<b>To:</b>	Chris Hanks	<b>Date:</b>	August 17, 2011
<b>Company:</b>	Hope Bay Mining Limited	<b>From:</b>	Maritz Rykaart
<b>Copy to:</b>	Melanie Smith, Angela Holzapfel, Kevin Mather, Calvin Goldschmidt	<b>Project #:</b>	1CH008.033
<b>Subject:</b>	Doris North Project Water Management – Remedial Measures for Leaking Pollution Control and Sedimentation Ponds

<b>To:</b>	Bob Princewright	<b>Date:</b>	June 8, 2011
<b>Copy to:</b>	Greg Blaylock, Kevin Mather, Calvin Goldschmidt, Doug Fielding, Jerry Graham, Ishan Fechter	<b>From:</b>	Maritz Rykaart
<b>Subject:</b>	Pollution Control Pond Liner Extension	<b>Project #:</b>	1CH008.033.213

Pollution Control Pond

**Liner Extension Zone**

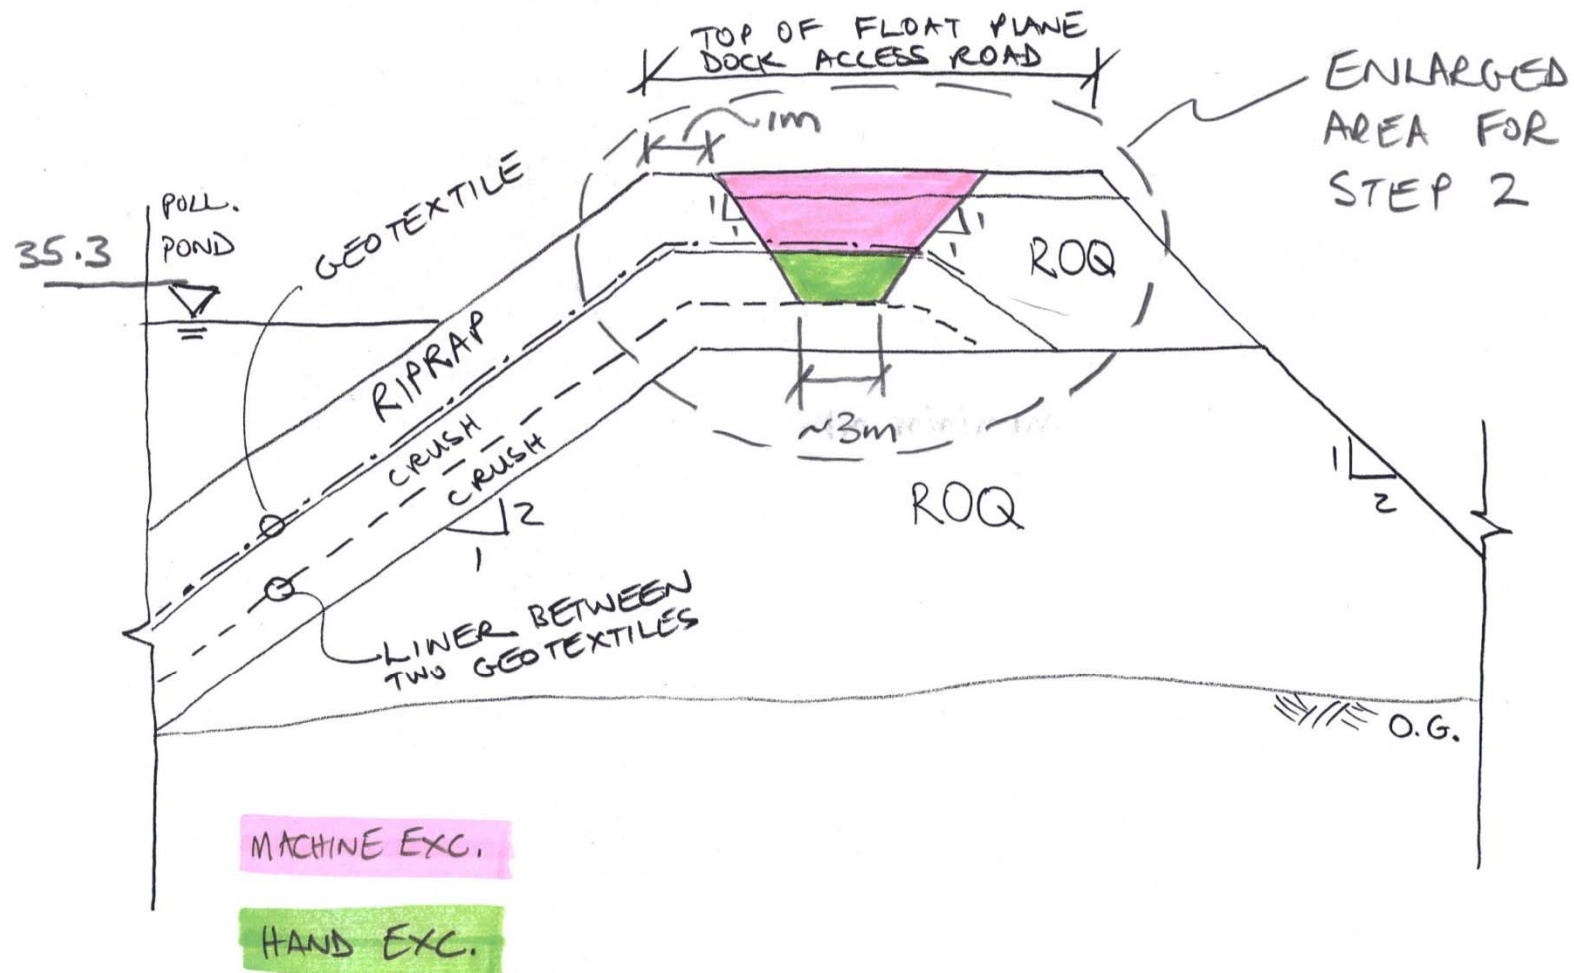
As stipulated in an email from Maritz Rykaart (SRK) to Kevin Mather (JDS) on May 31, 2011, SRK identified a design error in the crest elevation of the Pollution Control Pond. The pond design Full Supply Level (FSL) elevation is 35.3m with a freeboard elevation of 0.3m. This translates to a minimum design liner elevation in the Pollution Control pond of 35.6m. A review of the as-built survey of the liner crest has confirmed that the liner has been installed in accordance with the IFC drawings, but that approximately between stake-out points S2-22 and S2-48 (Drawing DN-DMC-16, Rev. 0) the crest of the liner is lower than the required 35.6m elevation. The variance ranges between 0.1m to 0.5m over a distance of about 65m.

- **STEP 1:** For a distance of about 75m, as shown in Figure 1, the liner must be carefully exposed. The extent of the required excavation is schematically illustrated on Figure 2. The excavation should start about 1m from the crest of the RipRap and the cut slope should be approximately 1H:1V (or as steep as practical bearing in mind the slope needs to be safe for people to work below the cut). Mechanical excavation methods can be adopted up to the point where the  $\frac{3}{4}$ " inch protective crush layer has been placed over the liner. Note this point is marked with a geotextile and should thus be easily identified in the field. Hand excavation techniques, or partial careful mechanical removal with a cleaning bucket should be adopted from that point on to remove the  $\frac{3}{4}$ " crush and expose the liner system. The base of the excavation should be between 2m and 3m wide.

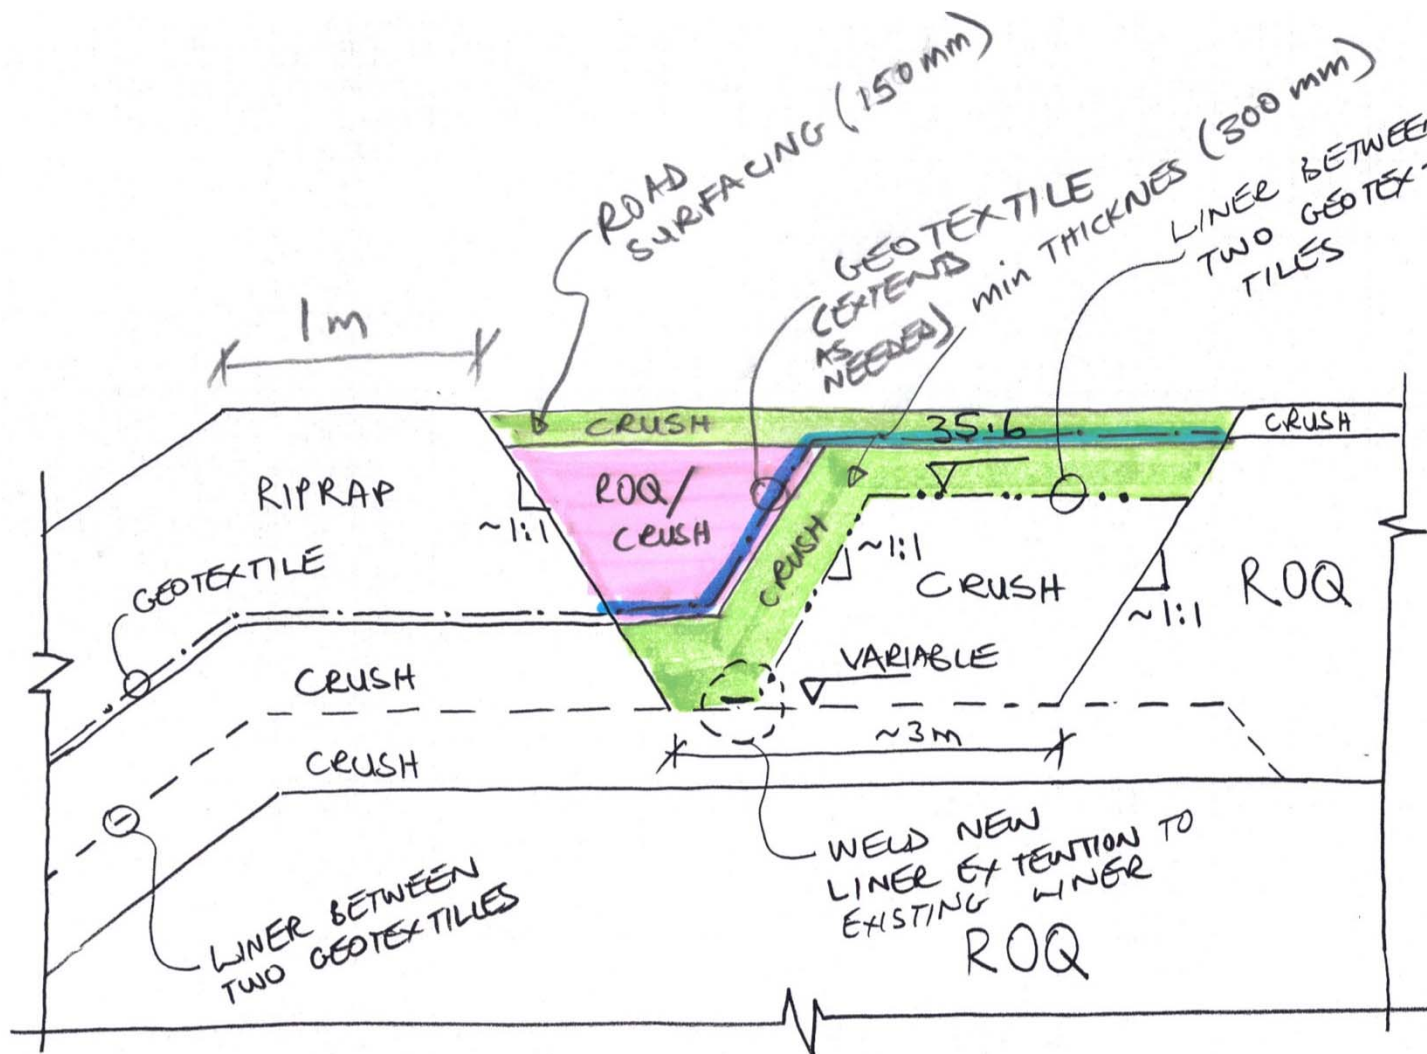
- **STEP 2:** A strip, at least 1m wide of the liner system, at the base of the excavation from Step 1 above must be thoroughly cleaned. The liner system must be cut along this horizontal surface to allow seaming of new strips of HDPE (sandwiched between geotextiles) to be extended as shown on Figure 3 (liner extension). A berm must be constructed immediately downstream of the liner extension using compacted crush material, to an elevation of 35.6m. The liner extension should be placed on this berm and extend horizontally by at least 1.5m at elevation 35.6 m. The liner extension will be composed of the same liner materials as the existing liner system. All seams must be completed, surveyed, and tested in accordance with standard liner QC protocols.

- **STEP 3:** The excavation of the liner must be backfilled using  $\frac{3}{4}$ " crush and/or select ROQ as appropriate based on the minimum dimensions shown on Figure 4.
